AGENDA
Planning Commission Meeting
June 23, 2026 @ 5:30 PM

1. Major Subdivision, Sketch Plan Review, Pagosa West

STAFF REPORT: Pagosa West, Major Subdivision, Amendment 2026-01, Sketch Plan Review

Figure 3: Conceptual Drainage

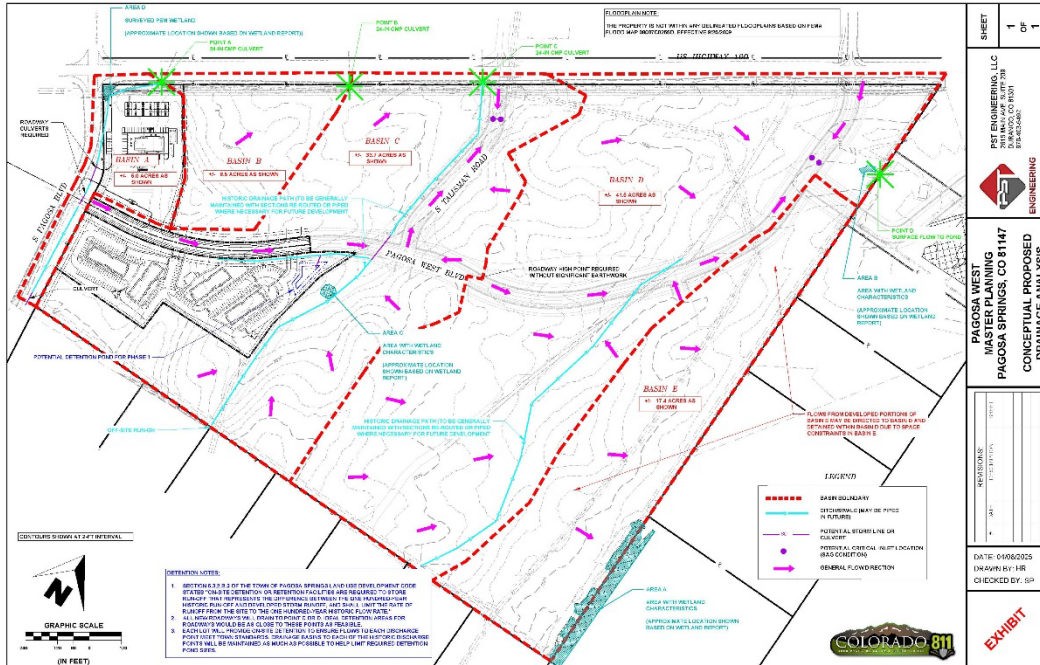
The applicant submitted a conceptual drainage plan with their application, which includes on-site and off-site detention for the developments within Phase 1. The developer also identified historic drainage basins with the intent of preservation through maintenance following the natural topography of the land (Figure 3 Below). The applicant identified 5 potential drainage basins based on the topography of the site to allow for the easiest transfer of storm water without

impacting surrounding areas. For the submission of the Preliminary Plan Review, a drainage study, prepared by a Licensed Professional Colorado Engineer will be required. Stormwater detention is required to be depicted at Preliminary Application for all roads, sidewalks and trails.

Figure 7: ACP

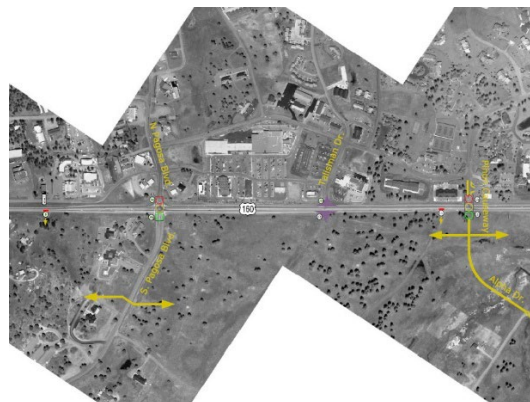
Internal Roadway design will be a function of the results of the Traffic Study. The main roadway, Pagosa West Drive, between S. Pagosa and Pinon Causeway will serve as a portion of the local road network contemplated in the Access Control Plan adopted by CDOT, Town and County. It is expected the Internal main road will be designed as a Major Collector Street serving more than 2,000 average daily vehicle trips and will separate the residential uses from the commercial uses. Accommodation for left-hand turn pockets should be considered for free-flowing traffic. Additionally, the development of internal roads will be phased out and detailed in their Development Improvement Agreement, that will be negotiated at the Preliminary Plan Review and executed at the Final subdivision application stage. The construction of internal roadways will be inspected by a qualified engineer and by the Town of Pagosa Springs Public Works Department. The newly developed roadways are intended to be adopted as publicly maintained roads by the Town of Pagosa Springs. The proposed subdivision's access points align with the jointly adopted Access Control Plan for US Hwy 160.

Figure 8: Proposed Trail Networks

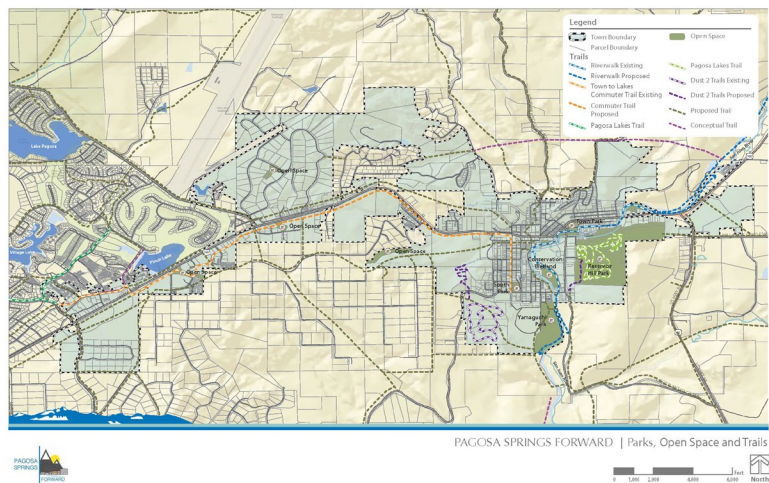
Town to Pagosa Lakes (TTPL) Trail: The concept sketch plan appears to be consistent with the intent of the TTPL trail plan as the commuter trail alignment easement is shown on the plan sheets. This section of trail should accommodate a 12-foot-wide trail with a 25-foot-wide easement width to accommodate drainage facilities and a meandering trail.

This proposal addresses both of these action items by establishing housing and trails that are near intermodal transportation, trails, and employment. Some of the largest employers in our community (Pagosa Springs Medical Center, City Market, and Walmart) are within walking distance to the proposed multi-family development. Additionally, the developer aims to provide connection to the Town to Lakes Trail Master Plan with their proposed pedestrian network. The developer has also identified areas within their development for transit stops that would provide downtown connection to residents.
